REMARKS/ARGUMENTS

Amendments to the Drawings:

Fig. 2

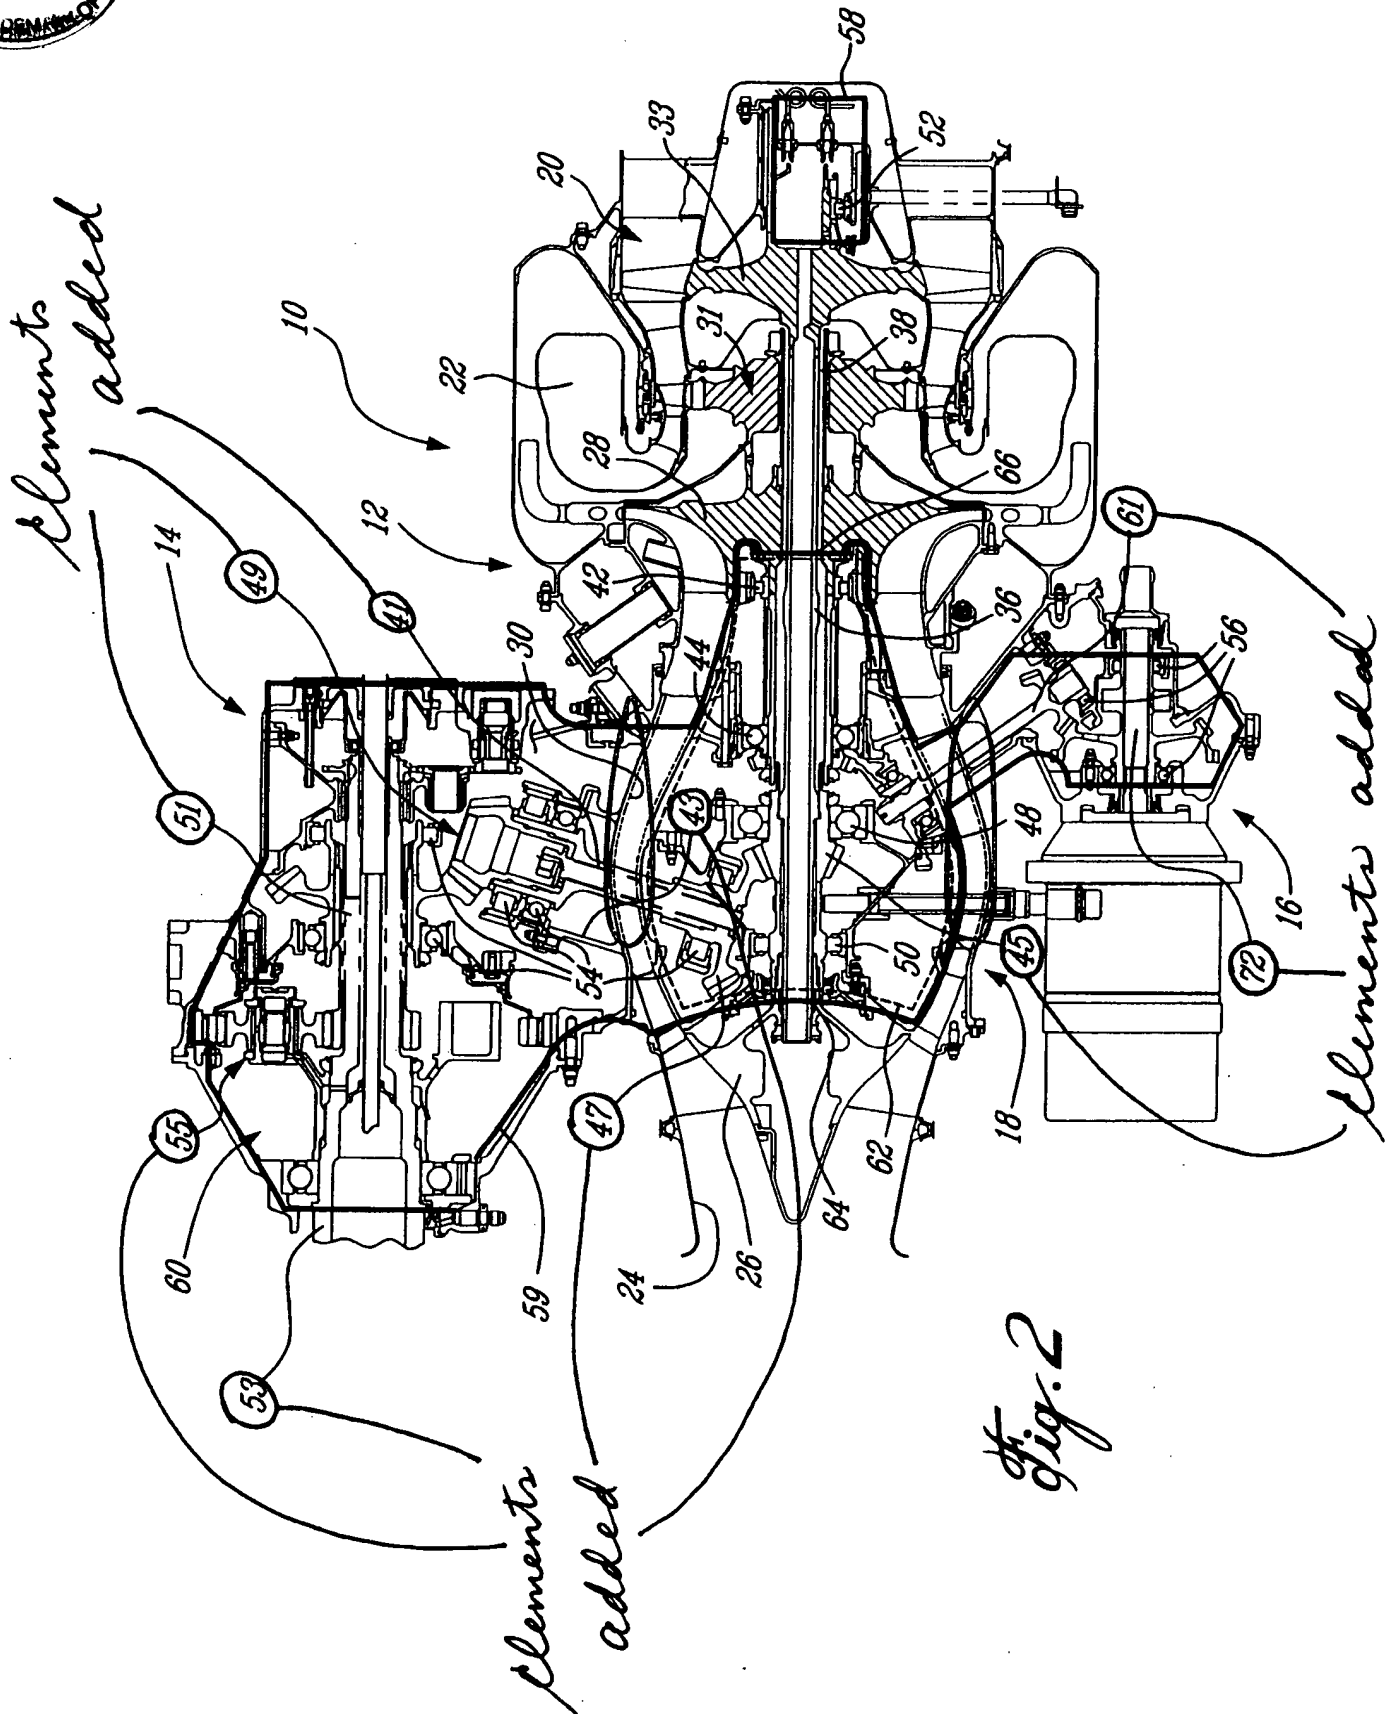
The drawings were objected to as failing to comply with 37 C.F.R. 1.84(p)(5) for failing to include several reference numerals mentioned in the description. The replacement drawing sheet (Fig. 2) enclosed herewith has been amended to add previously omitted reference numerals 41, 43, 45, 47, 49, 51, 53, 55, 61 and 72. Reference numerals 57 and 70 have been deleted from the description, and therefore have not been added. Reference numeral 30, contrary to the indication of the Examiner, was in fact previously present in Fig. 2. Reconsideration of the rejection to the drawings under 37 C.F.R. 1.84(p)(5) is therefore respectfully requested, in view of the replacement drawing sheet enclosed herewith.

The replacement sheet 2/2, which includes only Fig. 2, replaces the corresponding original sheet including Fig. 2. In the replacement Fig. 2, previously omitted reference numerals 41, 43, 45, 47, 49, 51, 53, 55, 61 and 72 have been added. The annotated drawing sheet enclosed shows the changes to Fig. 2.
